VEGP OLSEB
AMENDMENT 5

Insertion Instructions

FIGURE 3.9-2

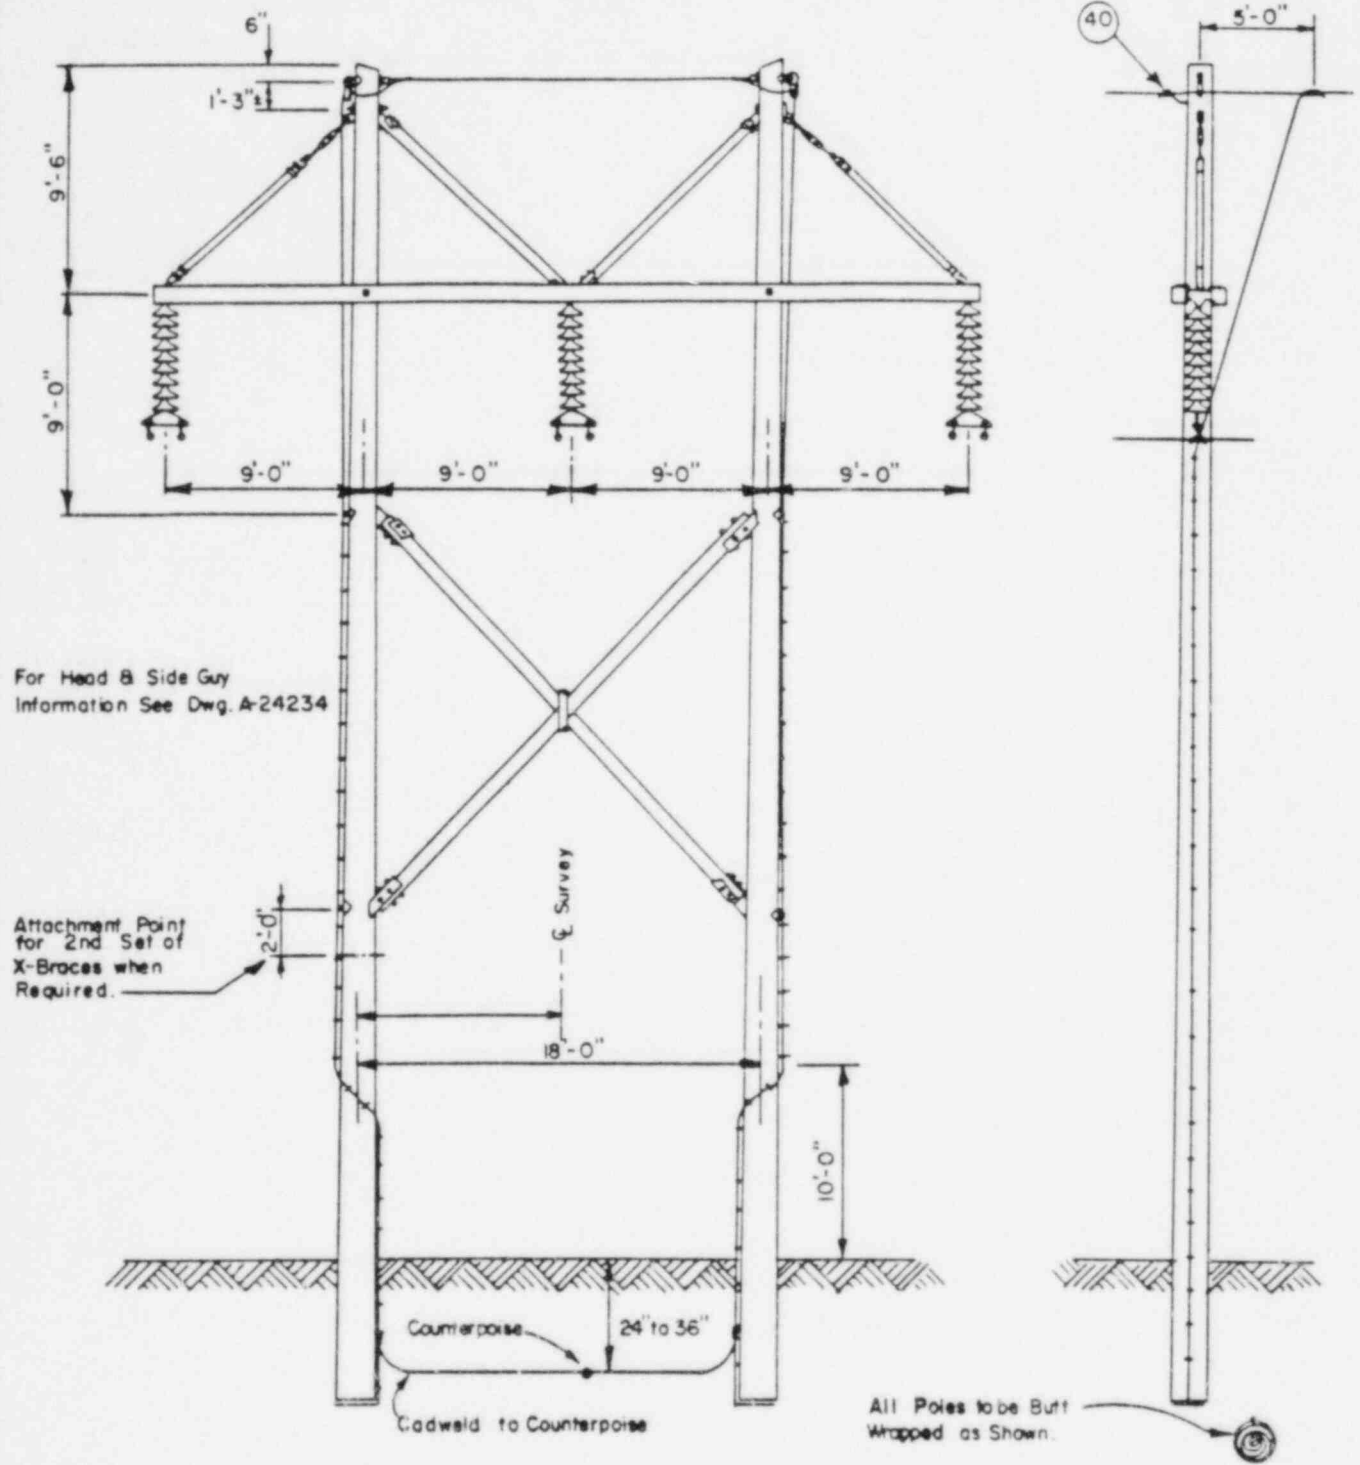
Figure 3.9-2 indicates the currently proposed transmission system. This system is based on current planning studies evaluating substation and interconnection needs for the Georgia integrated transmission network. Changes from the CPSER are due to a reduction from a four-unit plant to a two-unit plant as well as changes to construction schedules of substations and lines. The system described in figure 3.9-2 supersedes past system descriptions in the CPSER and intervening changes such as those described in Mr. D. E. Dutton's letter to D. G. Eisenhower of February 1, 1982.

Two 230-kV lines will go from VEGP to Goshen. These lines will share a common right-of-way approximately 19 miles in length with the existing 230-kV line which goes from Plant Wilson to Goshen.

A short single 230-kV line will go from VEGP to South Carolina Electric and Gas (SCEG). The route will involve approximately 3.8 miles of line on the Georgia side of the Savannah River and approximately 18.5 miles on the Savannah River Plant. The line will occupy approximately 36 acres of wetlands primarily in 1000- to 2000-ft stretches associated with Four Mile, Branch, and Steel Creeks. Most of these wetland areas can be spanned by the transmission lines by placing towers outside these areas. SCEG will be responsible for constructing the line. SCEG will be required to obtain Environmental Compatibility and Public Convenience and Necessity from the state of South Carolina pursuant to Utility Facility Siting and Environmental Protection Act (Title 58, Chapter 33, Code of Laws of South Carolina). All activities in South Carolina associated with the VEGP-SCEG line will be performed in conformance with the requirements of this law. The application for this certificate process has been initiated by SCEG. A copy of the application will be provided to the staff on or about June 1, 1985.

A 500-kV line will go from VEGP to Plant Scherer. This line will be approximately 152 miles long. This line is routed via the existing Wadley Substation but will not be initially interconnected at that point. This line is also routed via the Wallace Dam area, the site of a future substation.

It is projected that the entire network illustrated on figure 3.9-2 will affect approximately 6,500 acres. This is a reduction in the environmental impact from that originally evaluated at the Construction Permit Stage of approximately 12,600 acres.
